PROPOSED RESIDENTIAL DEVELOPMENT THE RESIDENCES AT 95 BREWSTER STREET PORTSMOUTH, NEW HAMPSHIRE PERMIT PLANS

RE: Request for Site Plan Approval at 49 Sudbury Street & 95 Brewster Street, Tax Map 138 / Lots 57 & 58

1) Prior to submission to Planning Board, plans shall be updated to address the following:

**GRADING AND EROSION
 CONTROL PLAN**

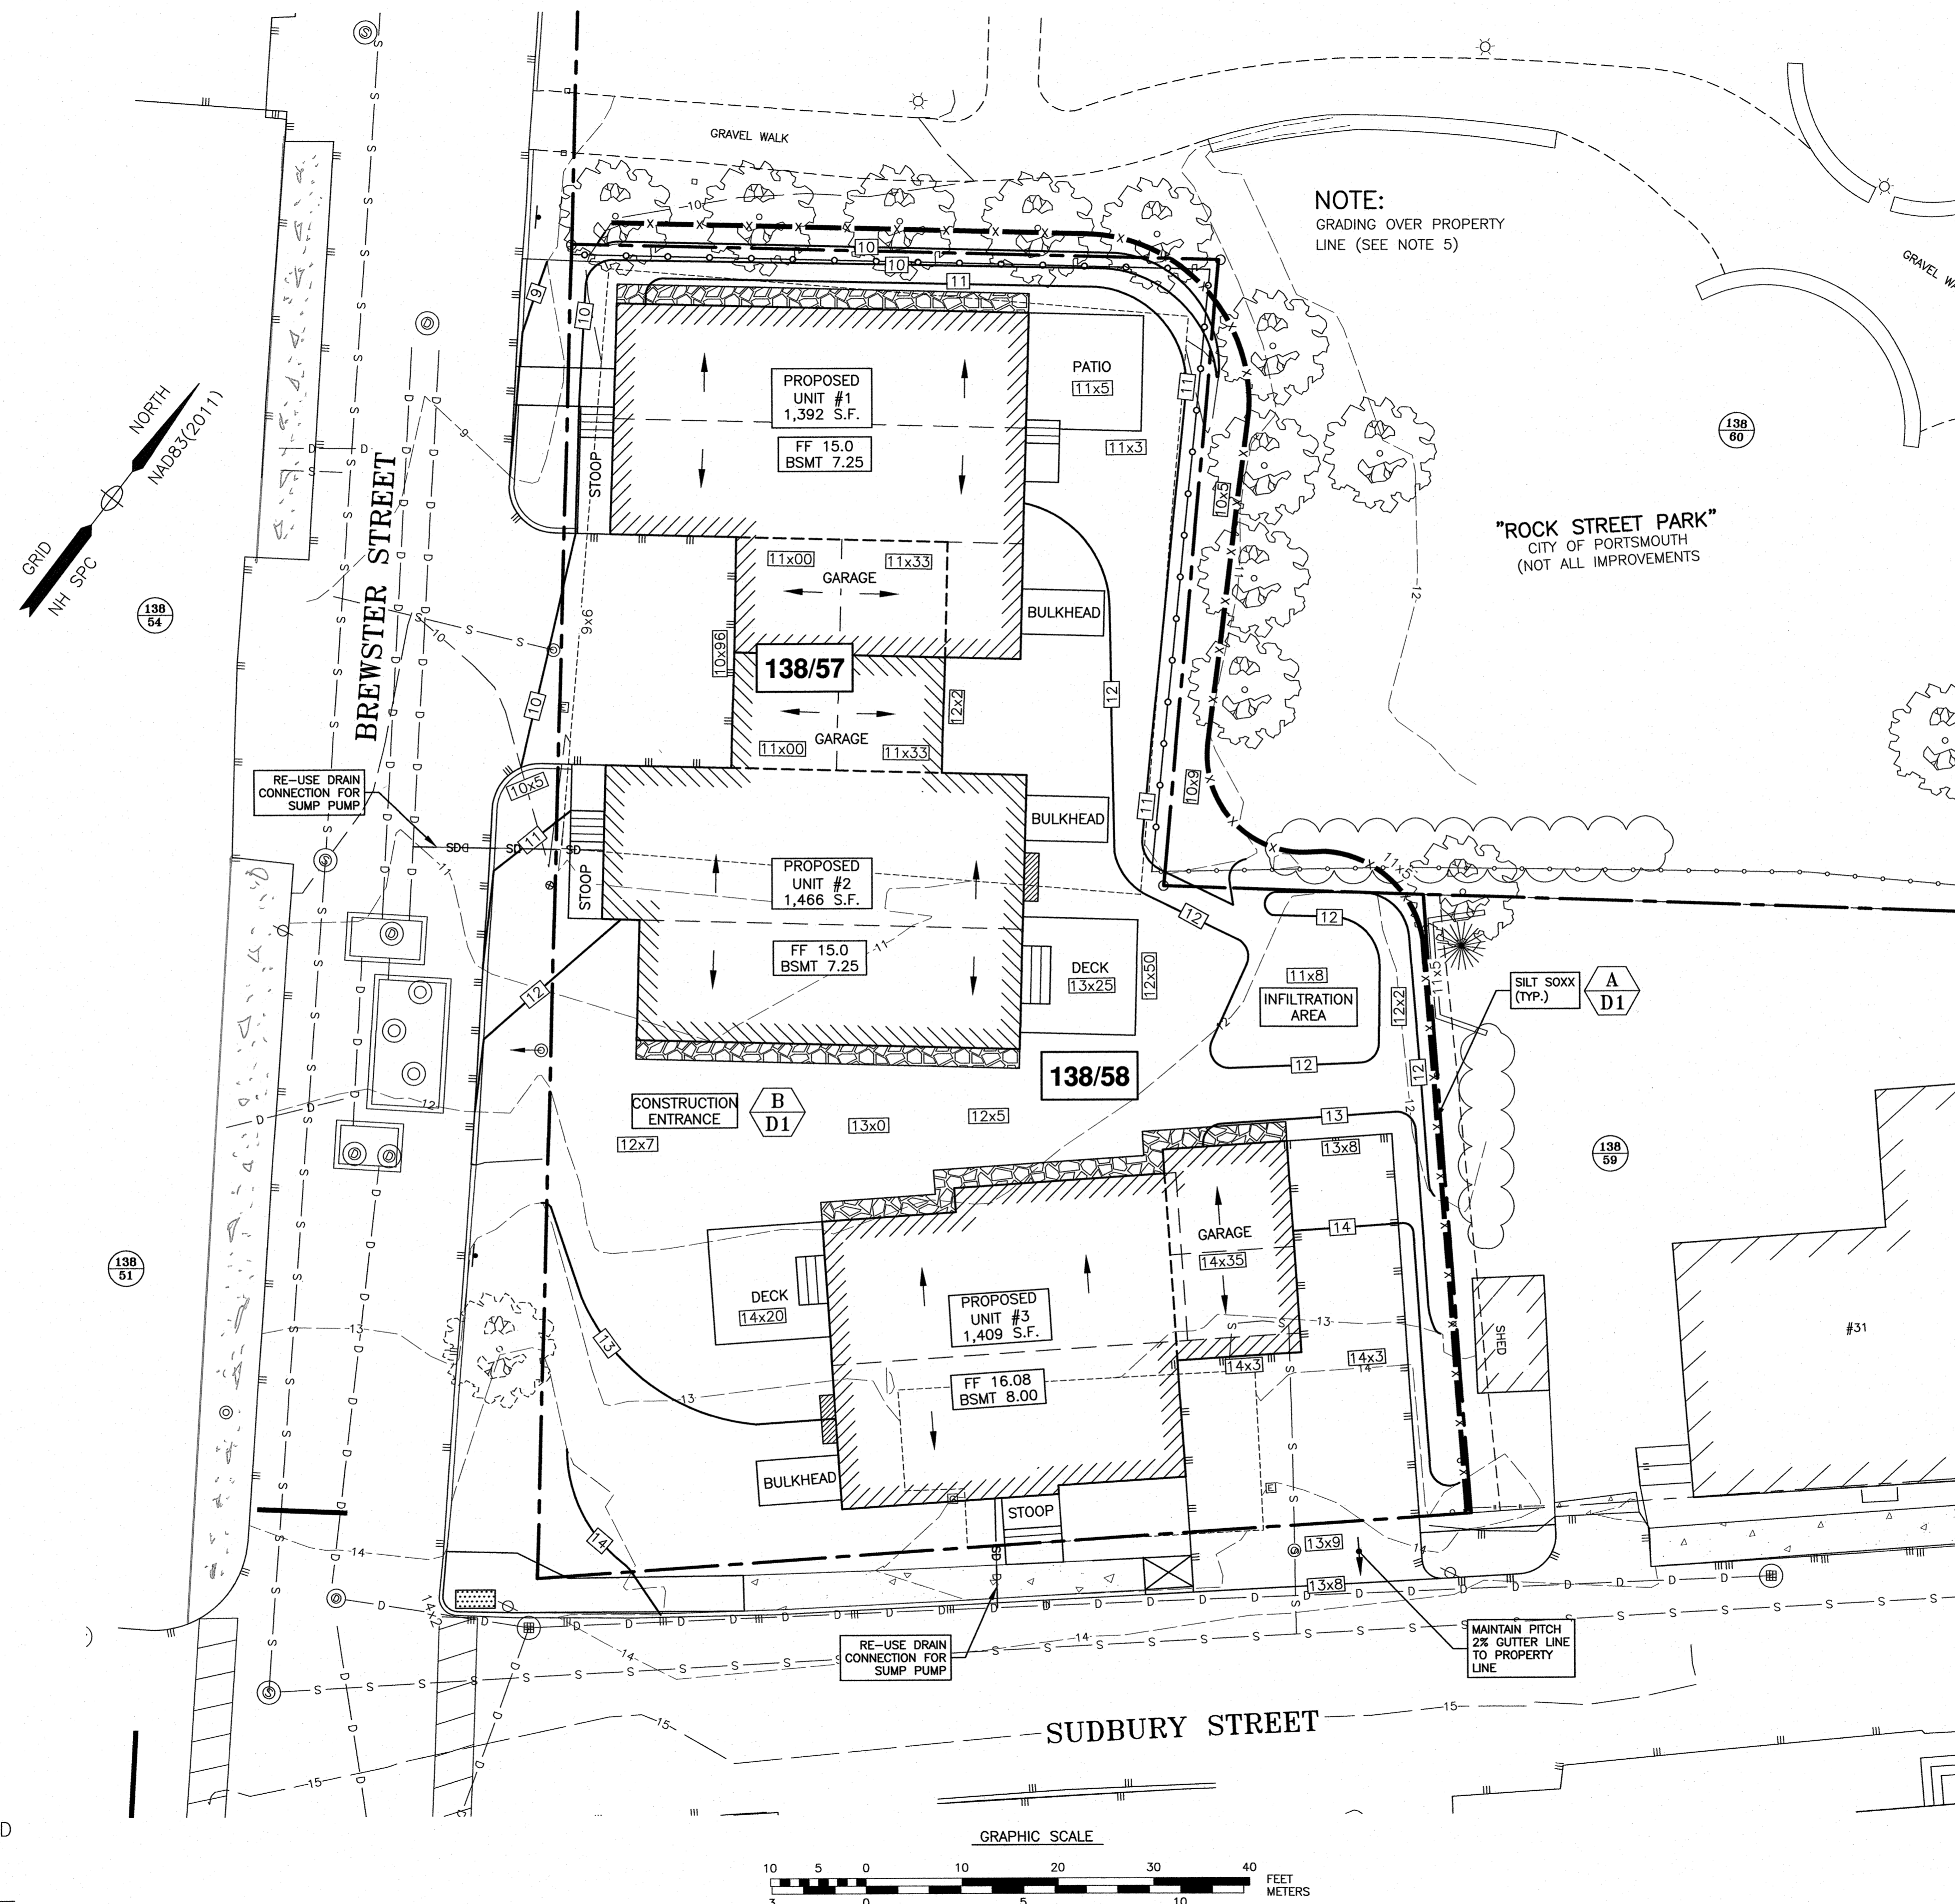
- c) Show with grading that Unit #3's driveway goes up in grade at 2% in the sidewalk area to conform to the ADA and to keep the storm water from Sudbury Street out of the yard; **See Sheet C4.**

- d) Show a swale along the common borders of Rock Street Park to bring the stormwater out around units 1 and 2 and out to Brewster Street. Grading on the City land may be allowed for the common good if necessary as long as plants are reestablished; **This has been added - see Sheet C4 and refer to Note 5 on that sheet.**

- g) The elevation 12 contour behind units 1 and 2 should tie into the 12 contour behind unit 3 and through the infiltration area. A retaining wall should not be needed here. Drain the infiltration overflow into the swale along the property lines out to Brewster Street; **The contours have been revise and the retaining wall eliminated - see Sheet C4.**

- h) Existing drainage connection to the Nickerson Remick building should be shown on the plans if it is to remain; **The drainage connection has been shown - see Sheet C4.**

UTILITY
PLAN

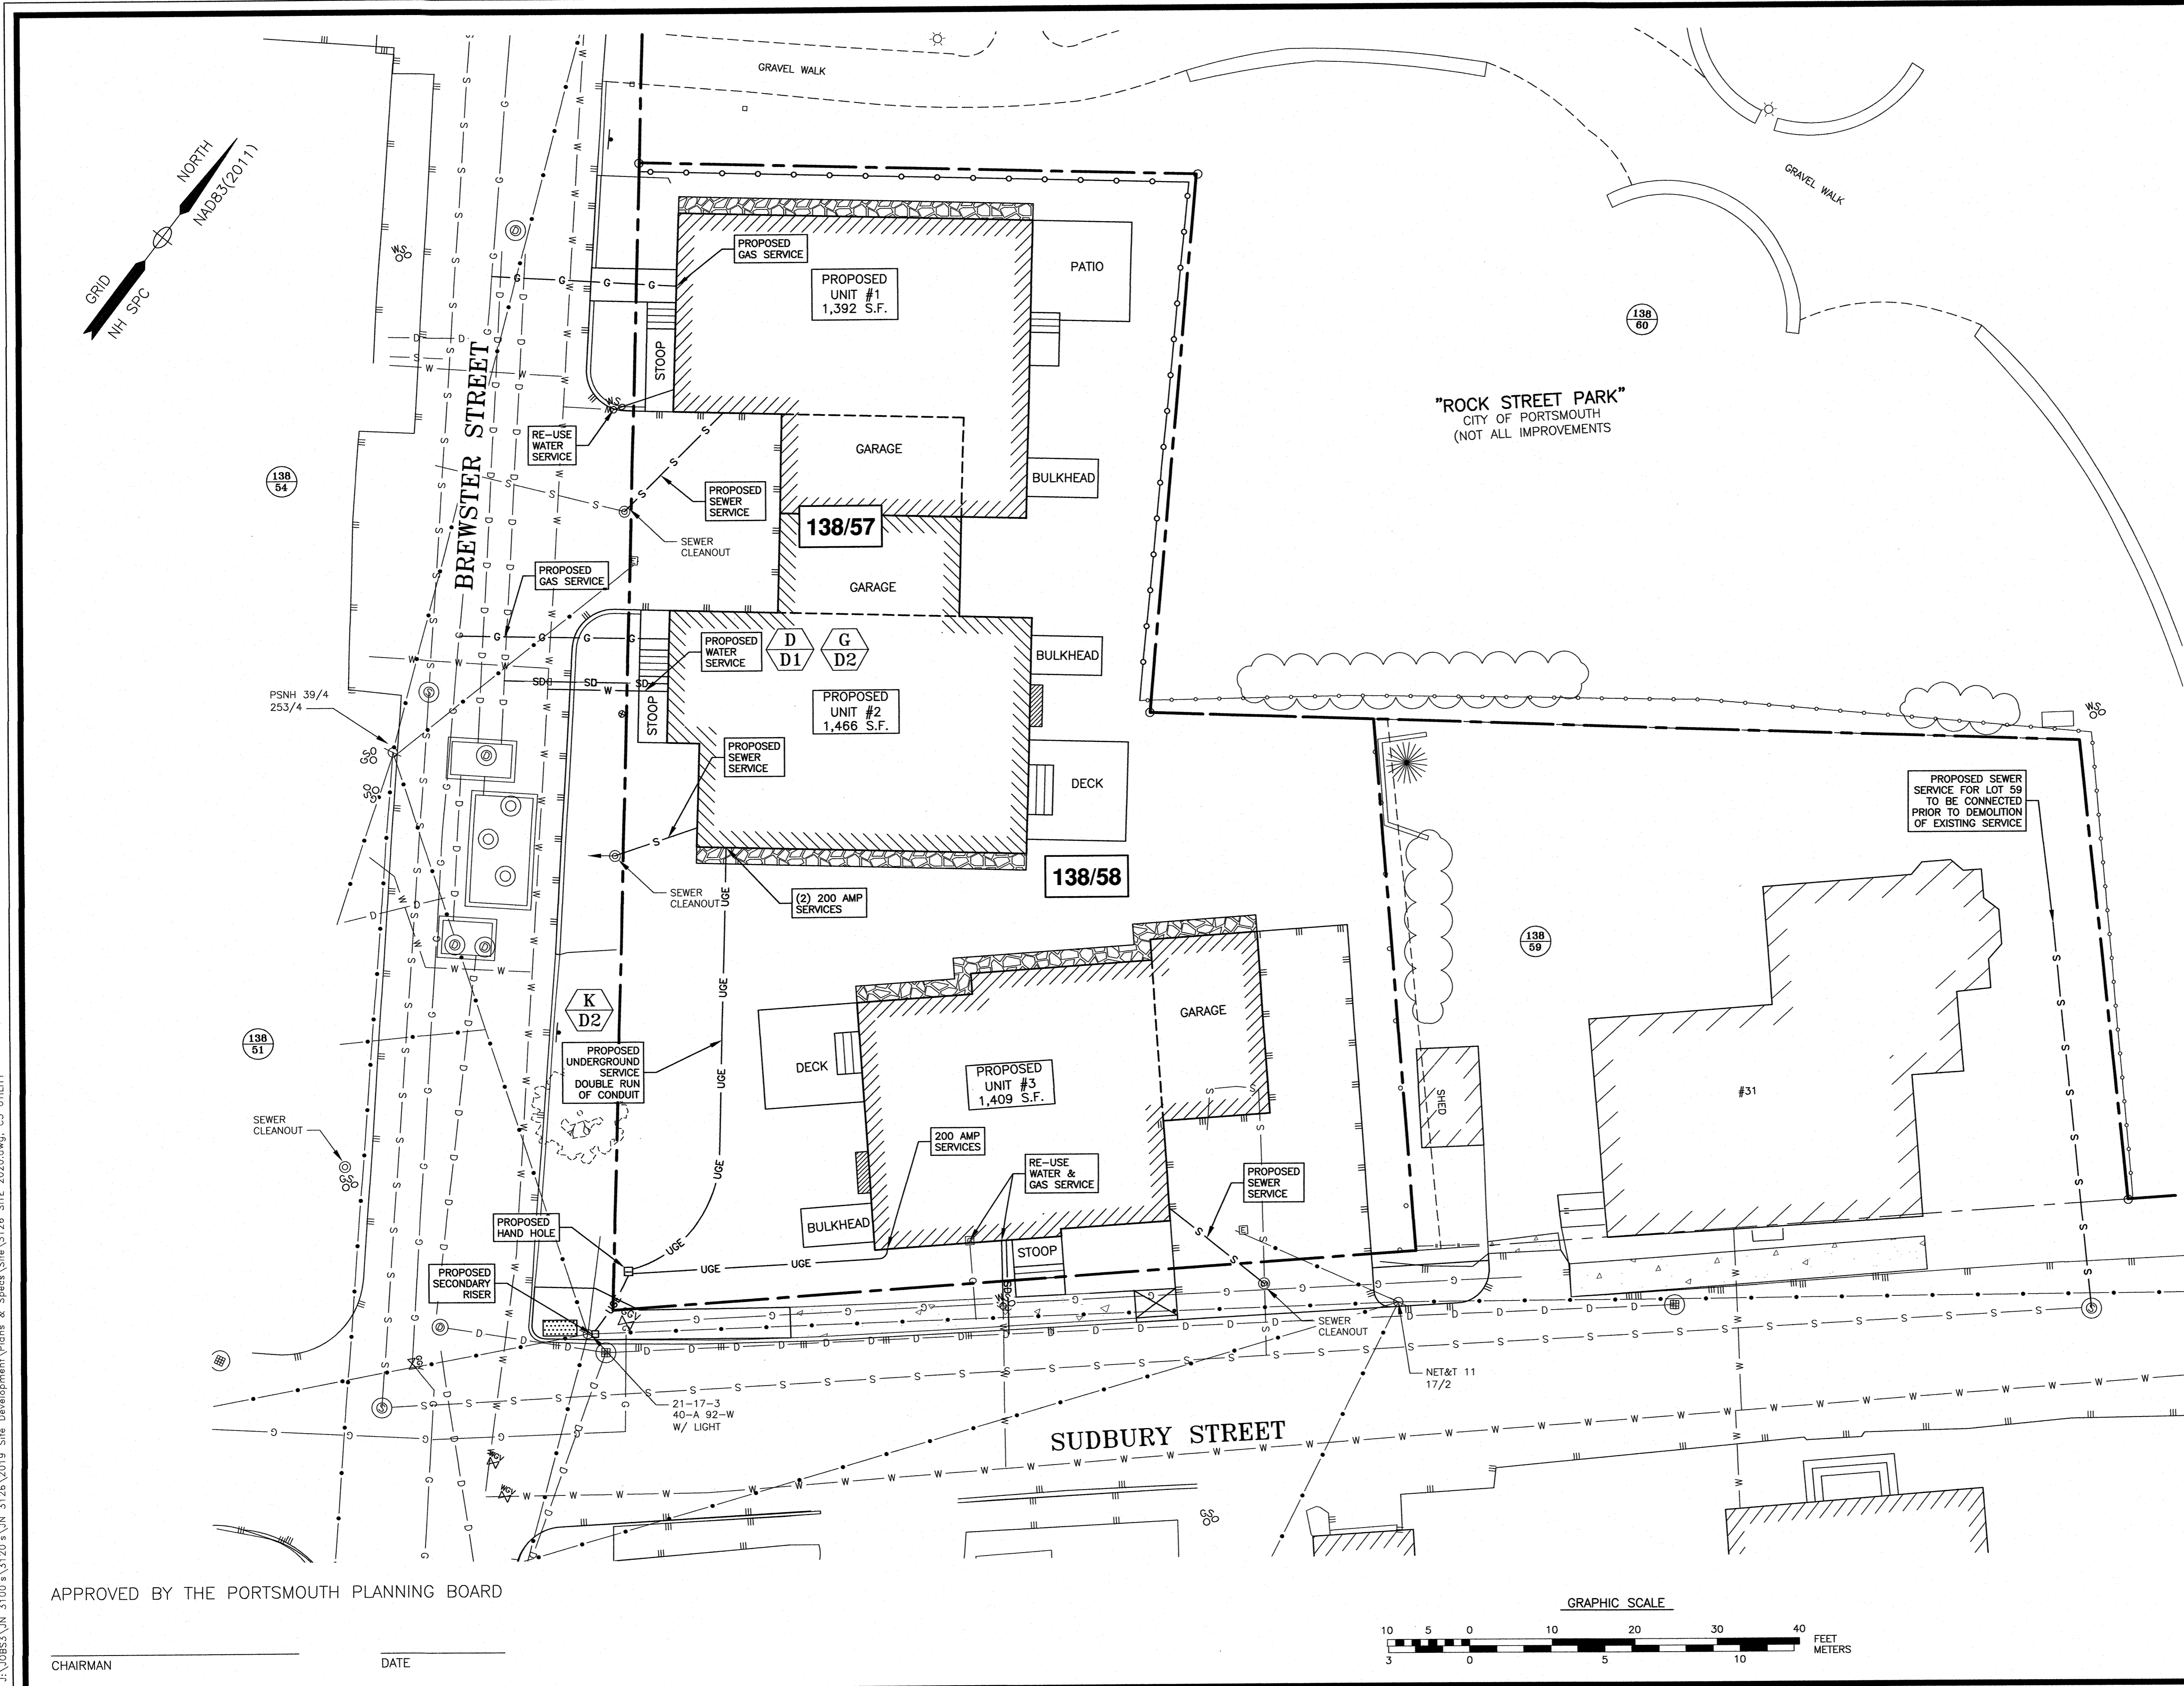
- i) Add note that the City will require street milling and paving in areas damaged by utilities or construction; **The Note has been added as Note 9 on Sheet C3 and as Note 7 on Sheet C5.**
